VICKERY EXTENSION PROJECT – REVIEW OF DETAILED RAIL SPUR DESIGN

NOISE REVIEW
RWDI # 2406615
11 August 2026

PDM-VY-PM-REP-0003_0

Figure 2-1: Rail Spur Alignments

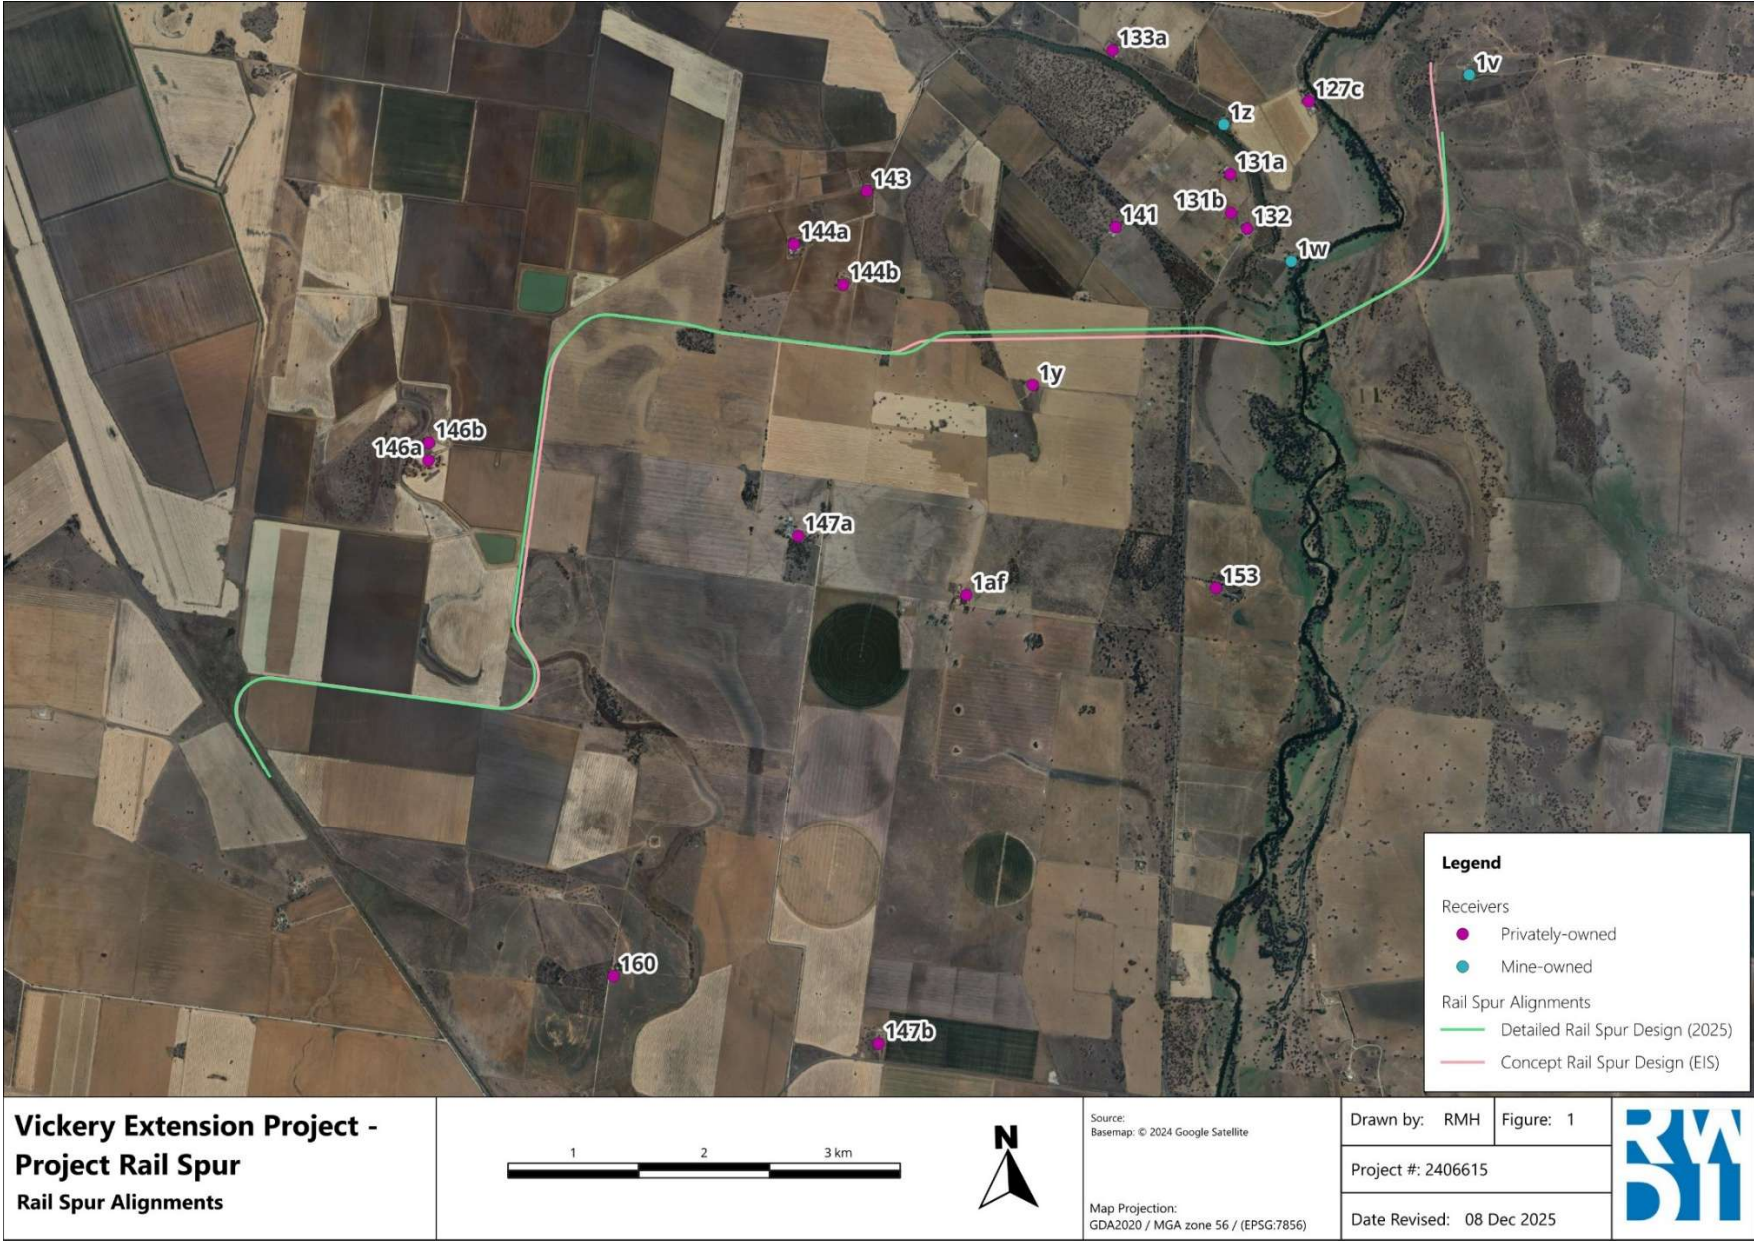
Despite some minor changes to the footprint, the detailed design of the rail spur alignment was found to be generally consistent with the VEP EIS, as shown in **Figure 2-1**. The maximum offset distance between the two alignments is approximately 65 m, which is considerably smaller than the separation distance between the rail spur and surrounding receivers. As such, this variation is not expected to result in any material change to noise levels at noise-sensitive receivers.

However, material changes to the design were noted in relation to the proposed structure of the rail spur:

1. The VEP EIS noise assessment generally assumed a rail viaduct on steel pylon-like structures over the floodplain between the ARTC rail network line and the Namoi River. In the detailed design, this was replaced for the most part by raised concrete culvert sections (average 2 m high) with ballast, extending from the ARTC rail network line to the Kamilaroi Highway (approx. 10 km).
2. The two rail bridges (Namoi River and Kamilaroi Highway Bridge and Stratford Creek Bridge), which had been assumed as steel structures in the VEP EIS, would predominantly consist of concrete structures (i.e. concrete piers [enclosed in steel tubes], pier heads, girders, decks and ballast walls) with ballast.

The above changes are expected to lower the amount of radiated noise emanated from the structure when compared with steel pylon-like structures (e.g. Maules Creek Coal Mine [MCCM] rail spur viaduct) assumed for the VEP EIS. Furthermore, the bridge/raised culvert structures and track design proposed as part of the detailed design would generally be considered best practice with regard to acoustic radiation efficiency, thus resulting in lower radiated noise from structures (including low-frequency noise). As such, the detailed design is deemed to incorporate all reasonable and feasible noise mitigation measures, including suitable measures to minimise low frequency noise.

It is also noted that the detailed design includes reduced rail elevations when compared with the concept design used for the VEP EIS – this would increase ground effects, thus providing more attenuation to noise propagating toward nearby noise-sensitive receivers.
